# Chief Mechanical Engineer's Building Submissions Report

<b>Title</b>	CME Submissions Report
<b>Prepared by</b>	Ethos Urban
<b>Accepted on behalf of Transport for NSW by:</b>	Toni Blume - Executive Director
<b>Signed</b>	
<b>Date:</b>	14 June 2023

**Figure 2:** Potential on-site parking spaces for CME building (end-state)

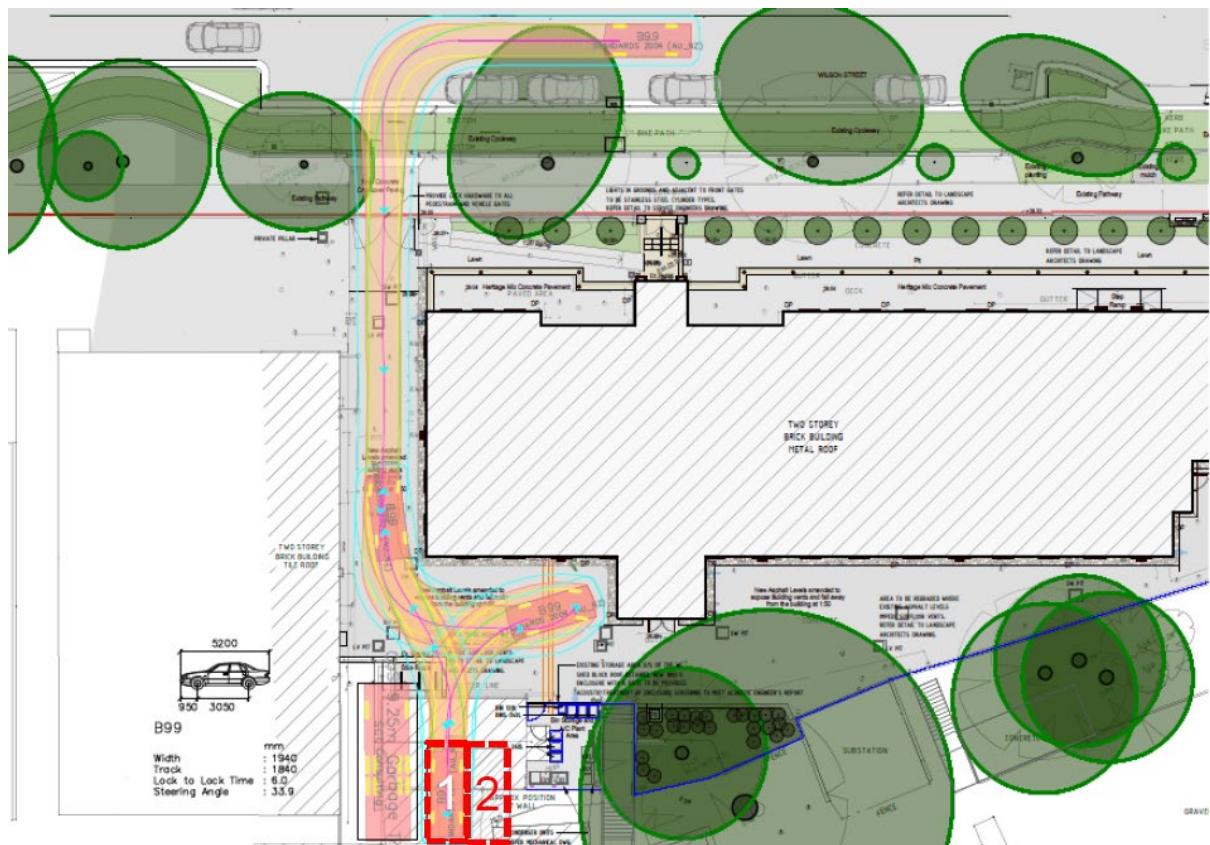
In the submissions received, it was requested the end-state traffic arrangements for parking and loading were clarified. Accordingly, the TTAS has been amended to address the below and can be found at Appendix N.

The Study notes based on the GFA of approximately 1,250m<sup>2</sup>, the use of the site would require a maximum of two parking spaces. In the end-state, should the toilet block be demolished in accordance with the concept plans for the Paint Shop Sub-Precinct, the site could accommodate either two parking spaces or one accessible parking space (with the associated shared space) as shown in **Figure 2** below. The Study does note however, given the interim site constraints and as the prescribed Council parking rate is a maximum rate, it is considered most appropriate for the Project to provide zero on-site parking.
